Tolerance (Inches)	 Memory Protection Devices, Inc. 200 Broad Hollow Road, Farmingdale, New York 11735		
Decimal	±.5 (.020)	Scale	Drawn By B.S.
Fractional	± .8 (.030)	Approved By T.B.	
Angular	± 3°	Date	Drawing Number
		10/07/19	APP-004

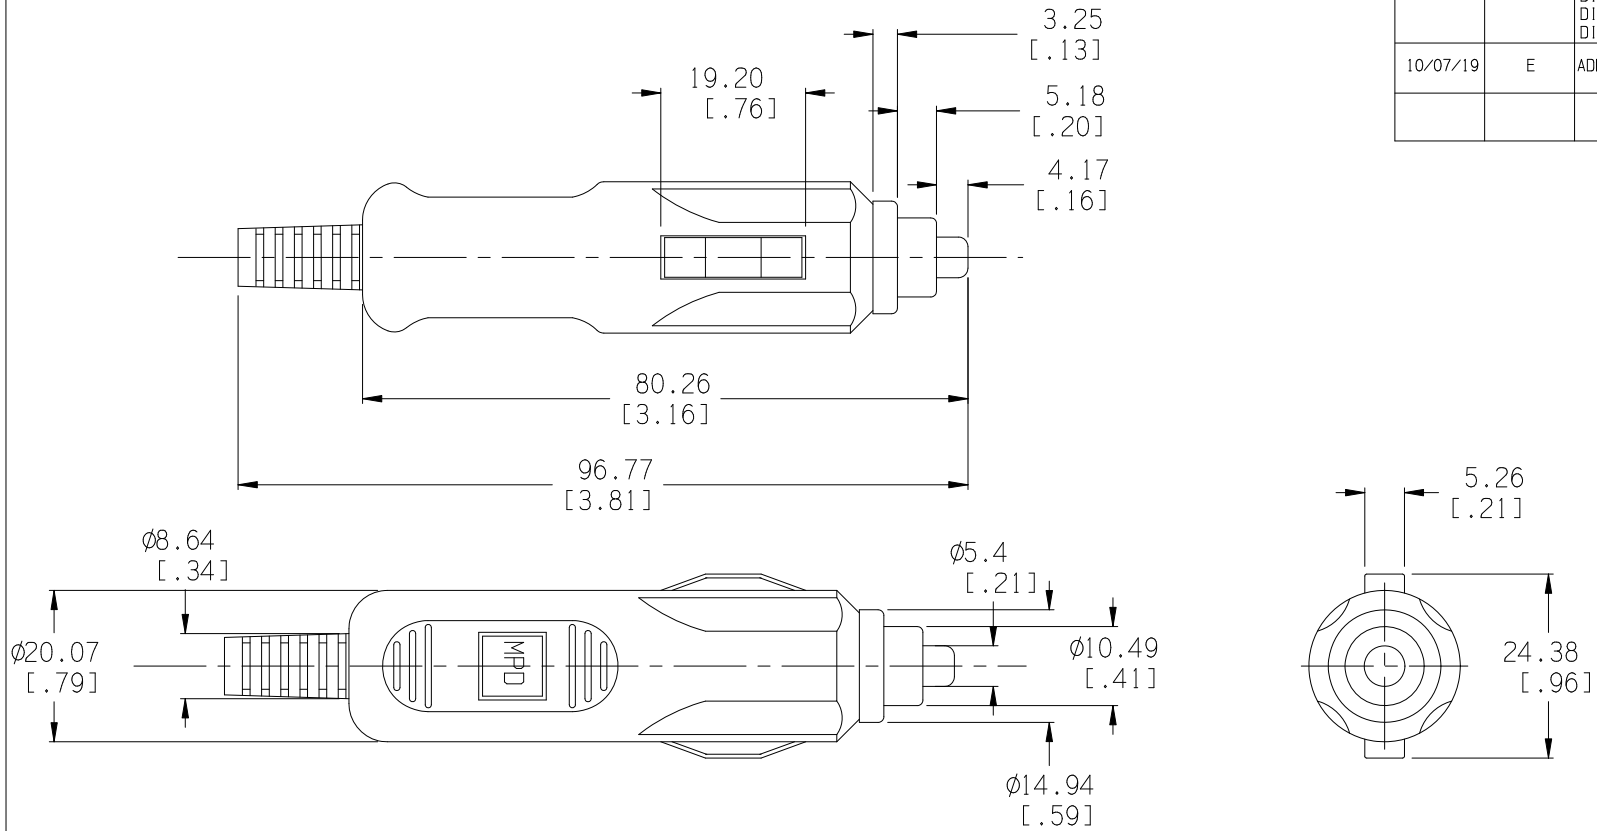
Date	SYM	REVISION RECORD	AUTH	DR.	CK.
8/28/14	C	UPDATED TO ROHS 2 COMPLIANT	T.B.	B.S.	
12/15/17	D	UPDATED SPECIFICATIONS DIM. 80.40 WAS 80.26 DIM. 24.60 WAS 24.20 DIM. 97.40 WAS 97.00 DIM. 20.00 WAS 20.10	T.B.	B.S.	
10/07/19	E	ADDED RING MATERIAL	T.B.	B.S.
